DUKE POWER

Subject: McGuire Nuclear Station, Unit 1
Docket No. 50-369
Request for Additional Information
TAC No. M89625/6

By submittal dated May 18, 1994, Duke Power Company proposed the integration of the McGuire Nuclear Station Unit 1 Reactor Vessel Material Surveillance Program with that of the Diablo Canyon Unit 2.

Figure 5-19.
Relationship Between Reactor Coolant System Temperature and Power

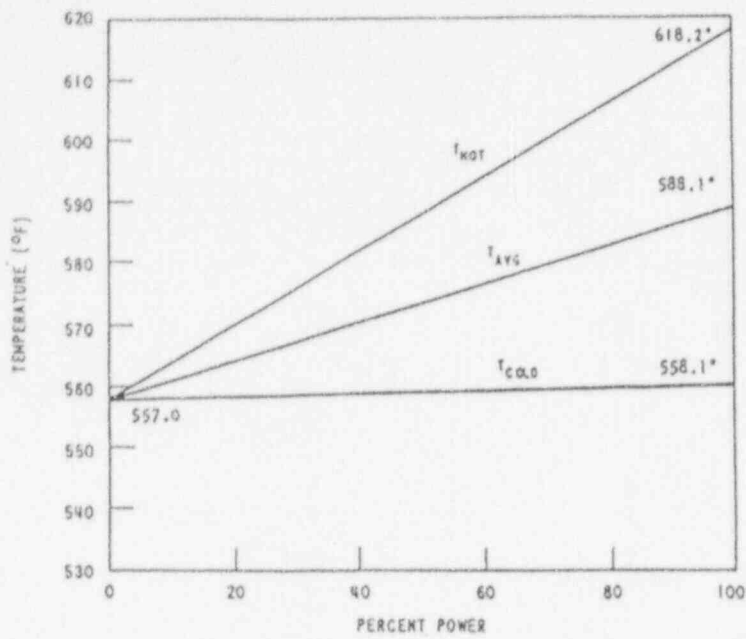
- 3) Provide the vessel inlet temperature for each fuel cycle at McGuire Unit 1 and Diablo Canyon Unit 2 because the staff does not know how and where those two Temperatures on Page D-6 were obtained.

As shown in figure 5-19 of the McGuire FSAR, T_{cold} remains fairly constant at approximately 558F. A Licensee Event Report search indicated the Technical Specification was violated once. The minimum NC system temperature of 536.7F was reached during a 79 minute event. This event is documented in the Duke Power Company, McGuire Nuclear Station Reportable Occurrence Report No. 370/83-62, dated December 1, 1983.

Attached are the McGuire and Diablo Canyon Reactor system temperature versus power curves found in chapter 5 of the FSAR.
